Re: NPDES Permit AR0021865; AFIN 08-00036
Additional Responses to Letter dated October 11, 2023
MCE Project No. 23-2159

Good evening. McClelland Consulting Engineers continues to assist the City of Eureka Springs in evaluation of the existing wastewater treatment plant equipment and function and has continued to work on final responses to your letter dated October 11, 2023, Request for Interim Measures, Bacteria Sampling, Communications Plan and Corrective Actions Plan. MCE and the city offer the following additional responses to your letter;

CITY OF EUREKA SPRINGS, ARKANSAS			
PHASE 1 - TREATMENT PLANT UPGRADE			
REVISED SITE PLAN			
USI Consulting Engineers Springdale, Arkansas	JOB	DATE	SCALE: 1"=30'
	0509068	11/07/07	
DRAWN	CKD	SHEET	
JLM	TWC	100A

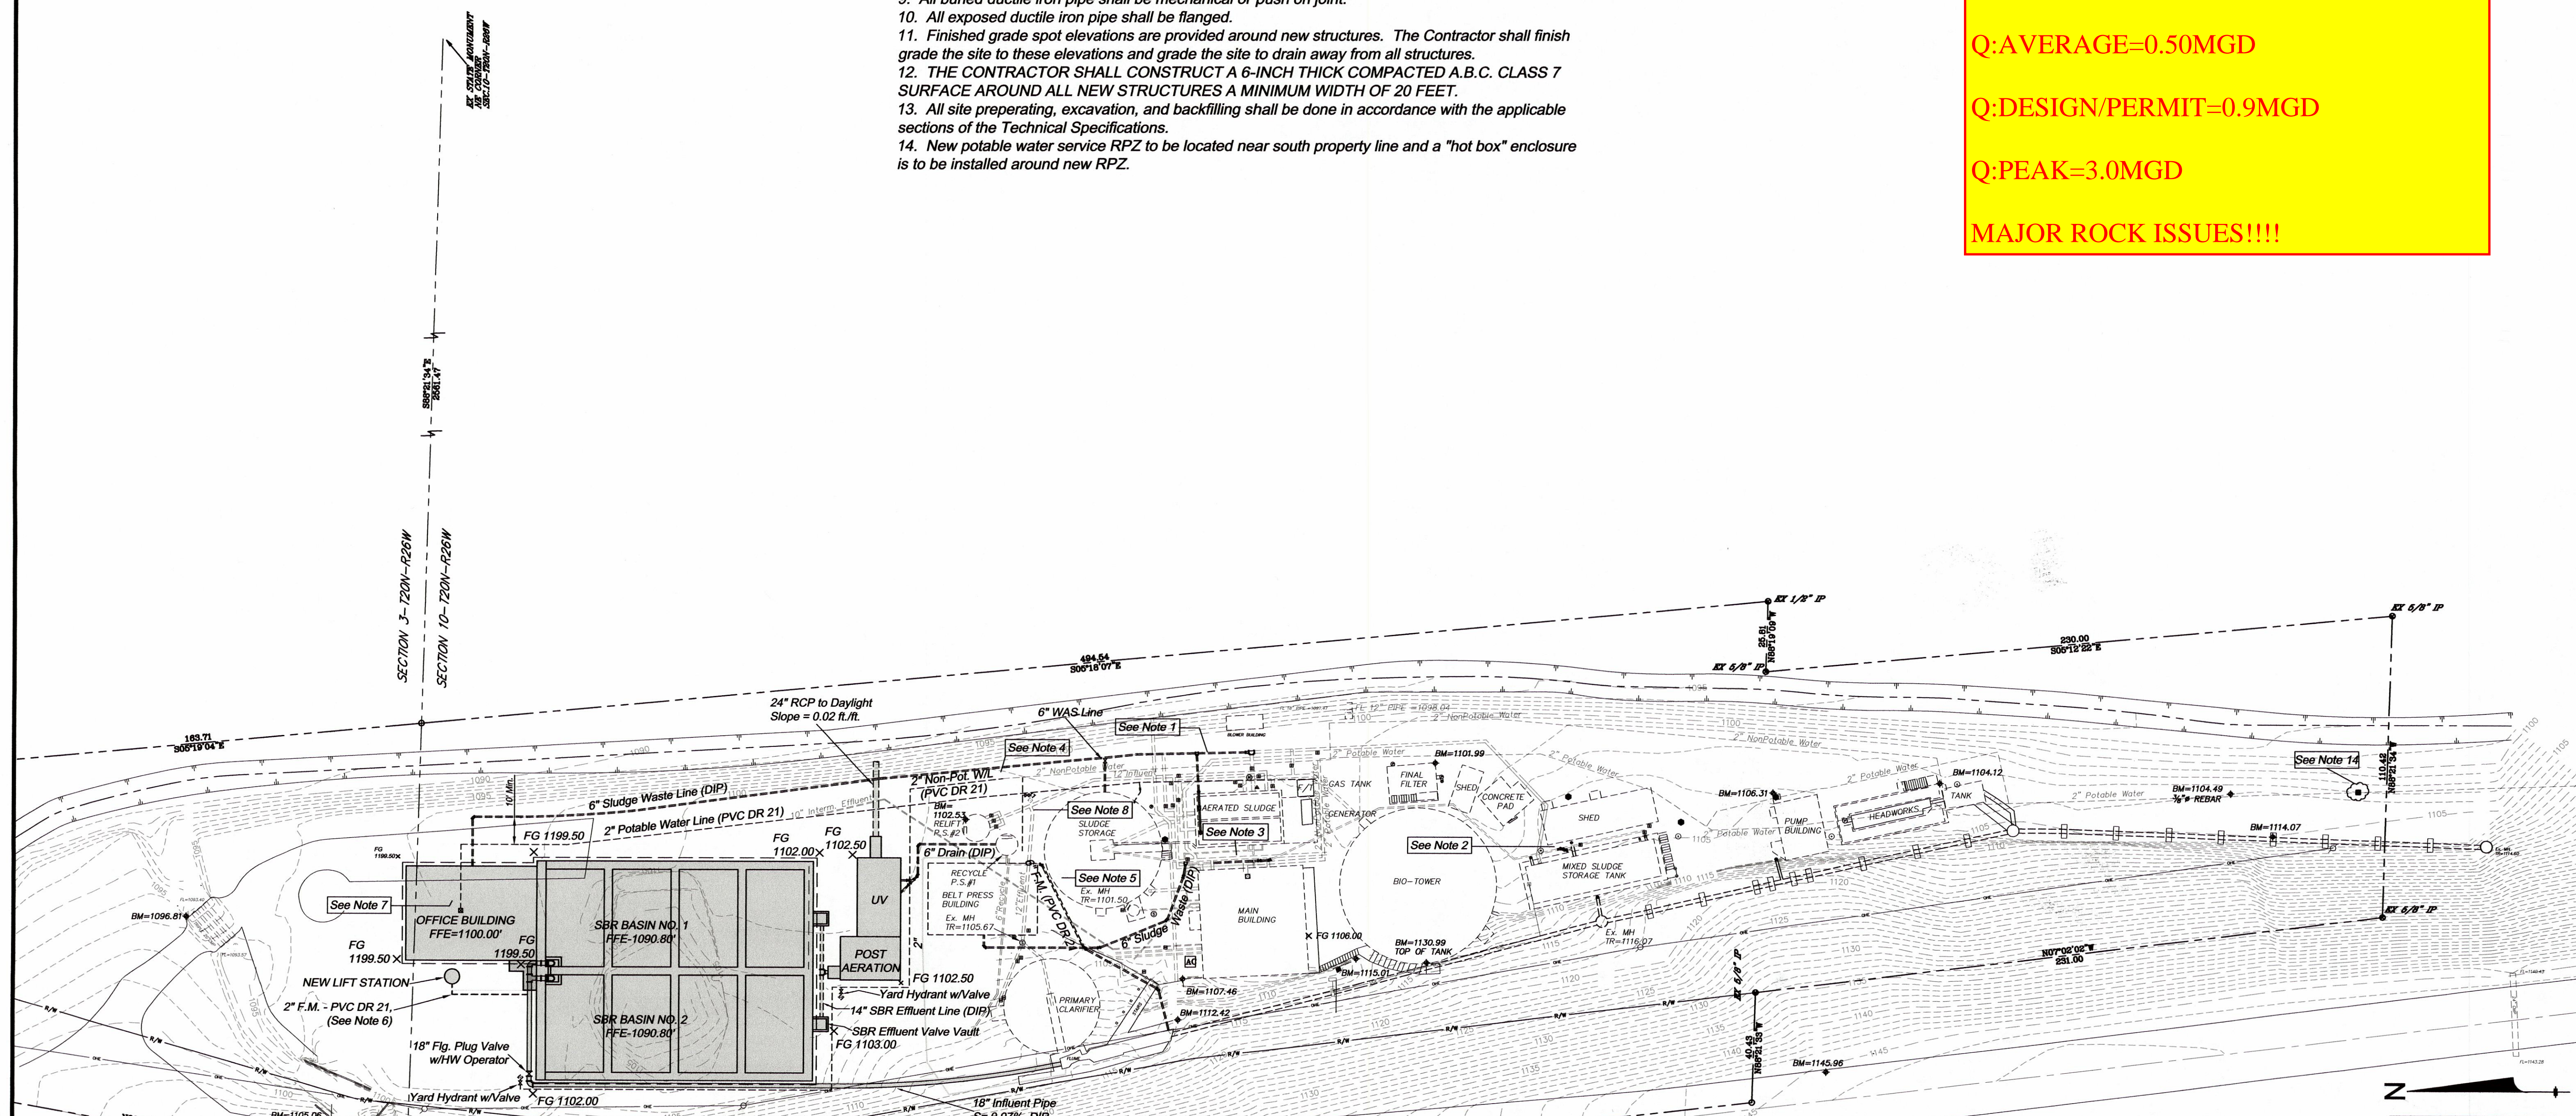
MCE recommends planning for full replacement of the existing screenings and grit removal systems, as shown on the attached Site Plan markup. New equipment will be located at the SBR reactor to potentially eliminate an intermediate site pump/lift station and reduce O&M and electricity costs. Without full replacement, or other

Multiple alternate equipment manufacturers have been contacted and are currently working on proposals for a new screening and grit removal facility that will be located much closer to the existing SBR reactor units. See attached existing asbuilt Site Plan that has been marked up with details for use for pricing. Pricing is expected soon and will be used to create a project budget for approval by the city council.

MAJOR ROCK ISSUES!!!!
